Service Bulletin

Bulletin No.: 17-NA-214

Subject: OnStar, XM, GPS or Antenna Malfunction – May Set DTC B2462, B2470 or B125C - and/or Water Leak on Headliner at Sun Visor or Overhead Console Areas, Possible Battery Drain Concern

4828697

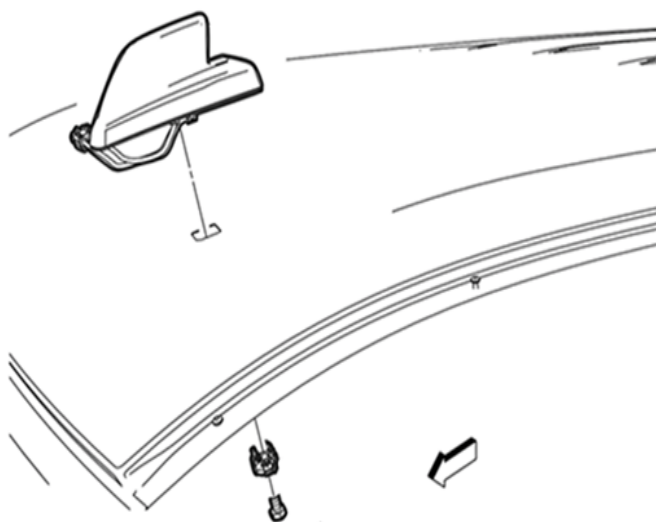
1. Remove the high frequency antenna. Refer to *High Frequency Antenna Replacement* in SI.

4828704

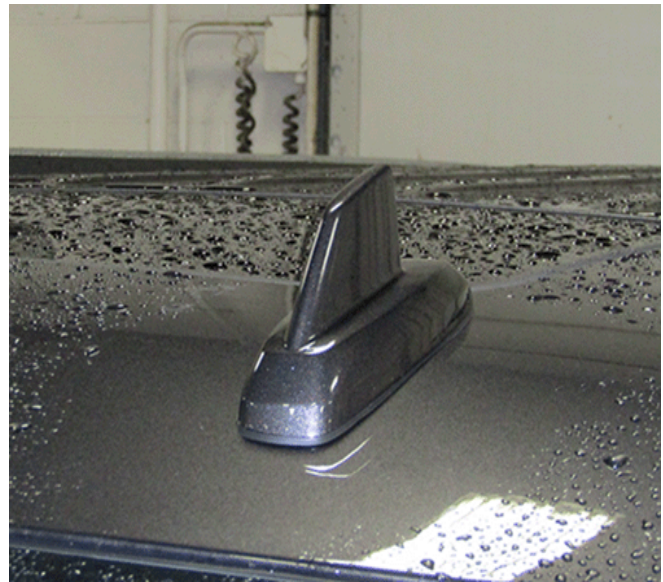
- 4.1. Locate the roof opening water seal (1) at the center of the antenna.

- 4.2. Apply a continuous, uniform bead of the seam sealer, approximately 4–5 mm in height, around the perimeter of the existing roof opening water seal.

Important: Ensure to keep the antenna electrical connector away from the sealer application. If sealer gets into the connector, the antenna would require replacement.

- 4.3. The sealer should be allowed to set-up only briefly - antenna installation should be done within five minutes of the sealer application.
